1964 - 1966 Corvette: Service Bulletin: Gear Shift Control Assembly Buzz

Subject: Gear Shift Control Assembly Buzz

Bulletin No: TSB #66-65

Date: June 13, 1966

FIGURE 1

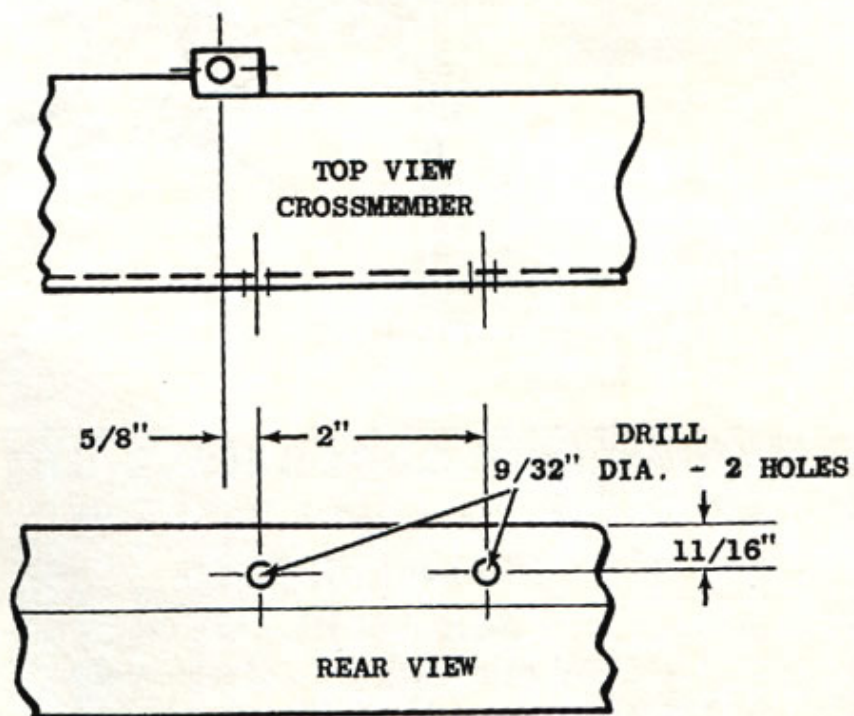
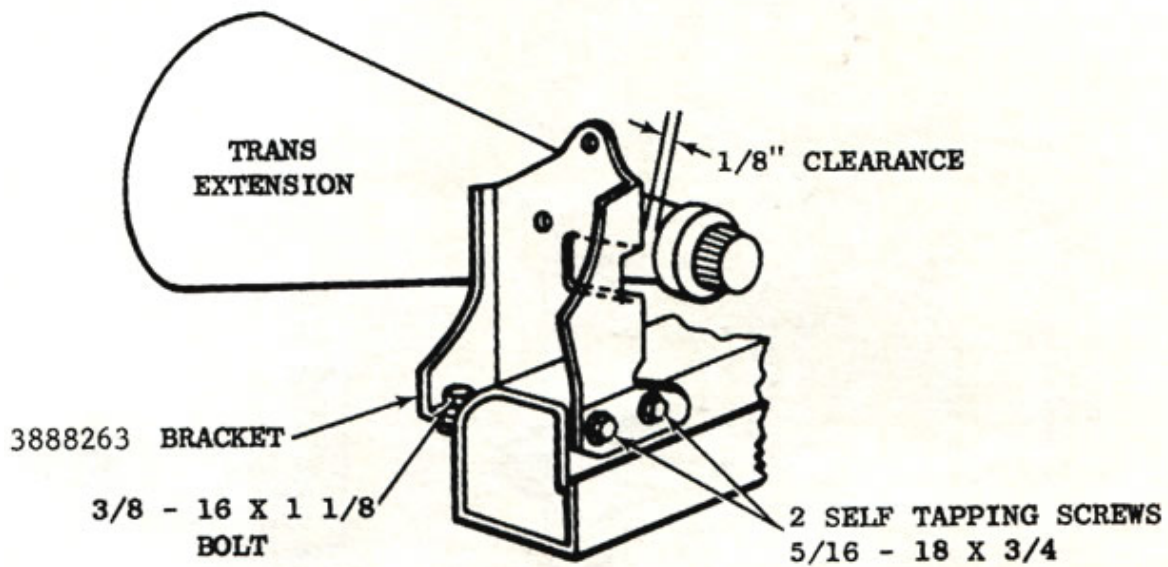
Complaints of shift control lever buzz on earlier units should be corrected by repositioning shift control assembly from the transmission housing to the frame crossmember. This is accomplished by removing the transmission extension mounting bracket and mounting the new bracket on the frame crossmember. Details of the repositioning procedure are covered on the following page(s).

7. Scribe a line 11/16" down from top surface of crossmember on rear side (See fig. 1.)
8. Move new bracket, Part No. 3888263, into position from rear of crossmember.

9. Loosely install bolt through front leg of new bracket through mounting tab on front of crossmember (center in slot). (See fig. 2, item 6.)
10. Using bracket as template, locate position of holes to be drilled at center of bracket slots. (fig. 1)

11. Remove bracket and drill two 9/32" holes in rear of crossmember. (See fig. 1.)
12. Loosely install new bracket using two 5/16" self-tapping screws and washers at rear attachment. (See fig. 2, items 4 and 5.)

15. Reinstall transmission mounting assembly and bracket and exhaust support. Tighten all bolts securely with exception of bolt holding new bracket.
16. Adjust new bracket laterally to provide desired 1/8"* clearance between transmission extension and bracket, then tighten bracket

screws securely. (See fig. 1.)

* Clearance in excess of 1/8" may cause binding in reverse operation.
